DUANE ARNOLD ENERGY CENTER
DOCKET 50-331
LICENSE No DPR-49
TECHNICAL SPECIFICATION CHANGE REQUEST (TSCR-029): "ADOPTION OF
NRC APPROVED GENERIC CHANGES TO IMPROVED TECHNICAL
SPECIFICATIONS"
AFFECTED TECHNICAL SPECIFICATIONS: SECTIONS 1.4, 3.3.1.1, 5.5.2, 5.5.11

EXHIBIT A
EVALUATION OF PROPOSED CHANGE

EXHIBIT B
PROPOSED TECHNICAL SPECIFICATION AND BASES
CHANGES (MARK-UP)

EXAMPLES

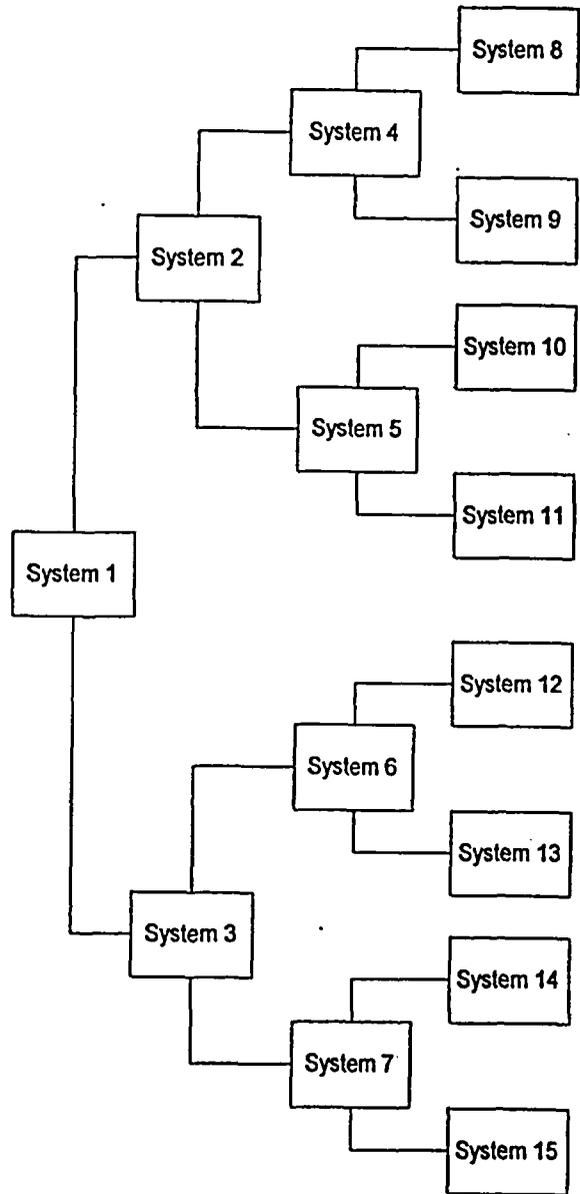
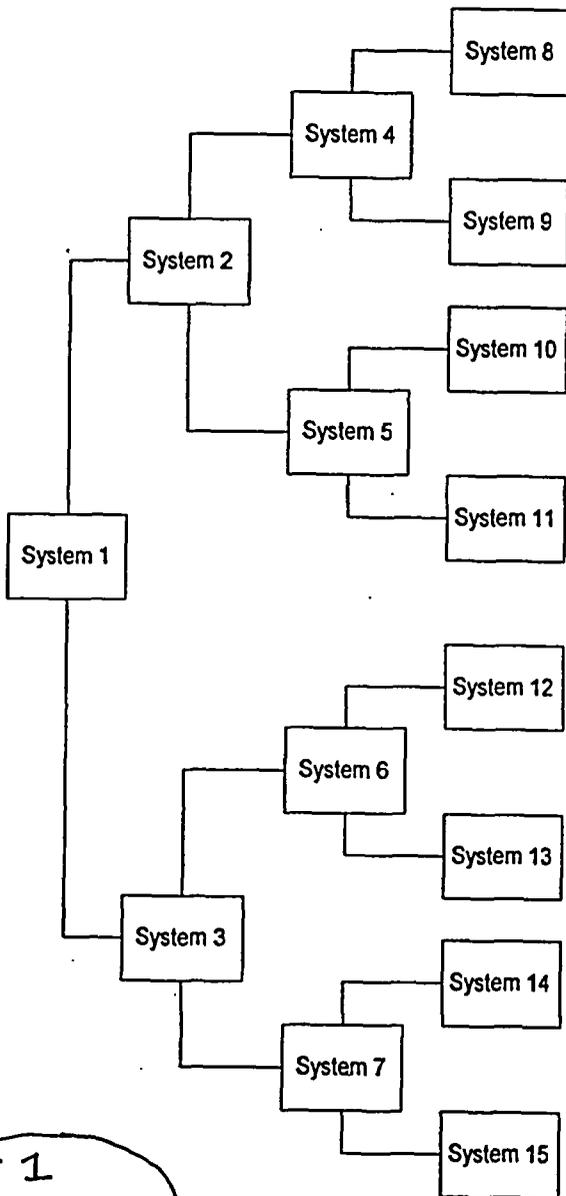
INSERT 1
from
TSTF-273, Rev. 2 →

This loss of safety function does not require the assumption of additional single failures or loss of offsite power. Since operation is being restricted in accordance with the ACTIONS of the support system, any resulting temporary loss of redundancy or single failure protection is taken into account. Similarly, the ACTIONS for inoperable offsite circuit(s) and inoperable diesel generator(s) provide the necessary restriction for cross train inoperabilities. This explicit cross train verification for inoperable AC electrical power sources also acknowledges that supported system(s) are not declared inoperable solely as a result of inoperability of a normal or emergency electrical power source (refer to the definition of OPERABILITY).
